Review of DHI hydrodynamic model for inundation assessment within the Kaipara Harbour

NRC have subsequently engaged Tonkin & Taylor Ltd (T+T) to undertake a review of the modelling and the resultant levels and inundation extents.

Figure 1 Example of 1 m shapefile (white) overlying 10 m raster image for CFHZ3

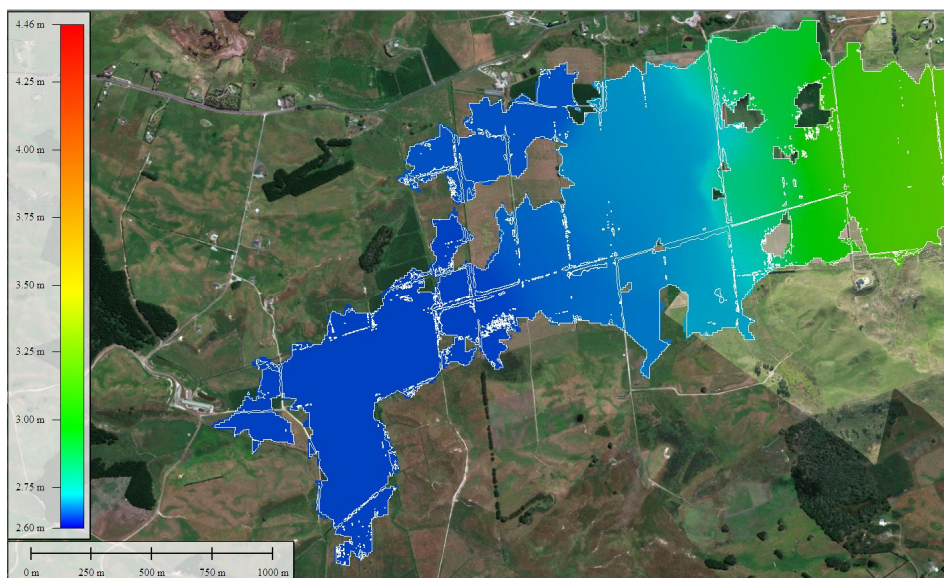
The remainder of the mapping appears reasonable, although the description of how the 10 m x 10 m raster values are mapped to a 1 m DEM is light on detail and a figure or some additional text describing the process would assist. The shapefiles have ended up quite fragmented (e.g. Figure 1) with many disconnected parts and may need some cleaning prior to use. We understand that this has been outside of DHI's scope of works but may need to be considered by NRC prior to use. Additionally, there are locations (e.g. Figure 2) where the raster appears to extend further landward than the 1 m shapefiles. DHI have indicated (B. Tuckey pers. Comm. 4/9/20) that this is due to the resolution of the raster, which is reasonable.
